# CITY PLANNING COMMISSION

APPLICATION: Special Permit to construct a 2,118+ square foot Long John Silvers Restaurant with a drive-up service window.

LOCATION: Southeast corner of Northgate Boulevard and Winterhaven Avenue

APPLC. NO. P88-152 MEETING DATE May 12, 1988 ITEM NO 17

**EXHIBIT A  
SITE PLAN**

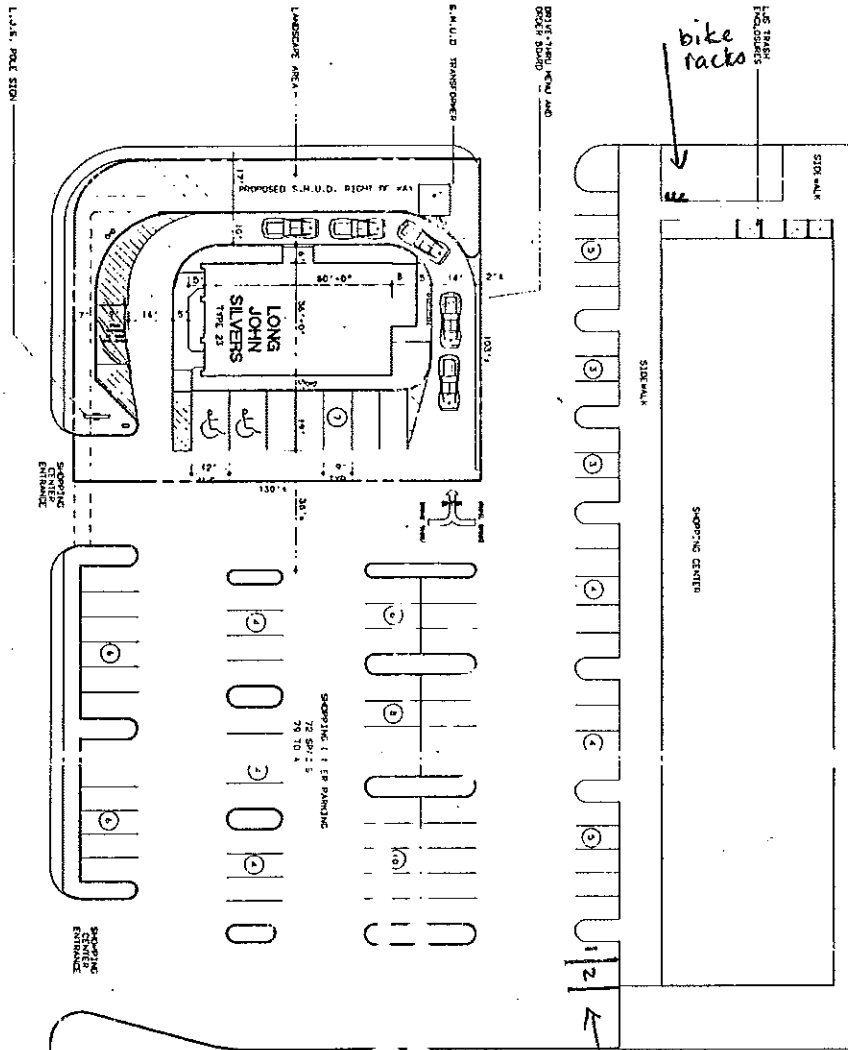
The proposed drive-up facility is in compliance with the proposed design standards for minimum width of the drive through lane, 11 feet is the minimum standard and the proposed lane is 14 feet wide. The entrance of the drive through is approximately 100 feet from either Winterhaven or Northgate and complies with the standard for a minimum distance of 25 feet from a public street.

The drive-up lane is not in compliance with the proposed ordinance condition for minimum vehicle stacking space for a facility with a separate ordering board and pick-up window. Although the drive through lane is approximately 240 feet in length, the pick-up window is located half way between the entrance and exit of the lane, thus reducing the effective stacking area to 120 feet. There is stacking area for three vehicles to the ordering board and three vehicles to the pick-up window.

The Institute of Traffic Engineers Design Manual recommends that fast food facilities provide stacking area for five vehicles to the order board and stacking area for five more vehicles to the pick-up window. The applicant has met with the Traffic Engineering Division and has provided evidence that Long John Silver's Seafood Shops actually fall under the Institute of Traffic Engineer's definition of a "high volume sit down restaurant" rather than a fast food restaurant. The traffic generation for this type of facility is significantly less than for a fast food restaurant. The applicant's study showed a typical total volume per day of 136 orders (including inside orders), as compared to a typical total volume per day for a fast food restaurant which ranges at 400-500 orders per day.

The Traffic Engineering Division has reviewed the applicant's site plan and supports the drive-up window design. The purpose of requiring a Special Permit review of drive-up services facilities rather than set standards was to allow for flexibility in application of the standards and review of each facility on a case-by-case basis. This facility

appears to have adequate stacking distance for the volume of business.

The shopping center presently has 73 parking spaces. The site plan for Long John Silver's depicts seven parking stalls and one parallel stall. The City does not permit parallel parking stalls, therefore, the total proposed parking for the site is 80 parking stalls. The combined parking required for the shopping center and Long John Silvers is 82 parking spaces.

The two additional parking spaces can be provided at the southeastern corner of the parking area if the existing bike racks are relocated to the northeastern corner of the site, as shown on Exhibit A. The other alternative is that the applicant reduce the capacity of the restaurant by six seats. Staff is not supportive of a variance from the required parking as there is no circumstances unique to this proposal that would justify the granting of a variance and thus, granting of a variance in this situation would be a grant of special privilege.

1. The applicant shall submit a landscape plan for staff review and approval prior to issuance of building permits. Provide interior landscaping and screen the SMUD transformer.
2. The applicant shall record the lot line merger for the site prior to issuance of building permits.
3. All trash enclosures shall be designed to City standards.
4. The applicant shall provide additional parking spaces and relocate the bike racks, as shown on Exhibit A or reduce seating for the restaurant by six seats, for a total capacity of 78 seats.
5. A signage program shall be submitted for review and approval of staff prior to issuance of sign permits. Detached signage shall be monument type and shall not exceed 12 feet in height measured from the top of the sidewalk.
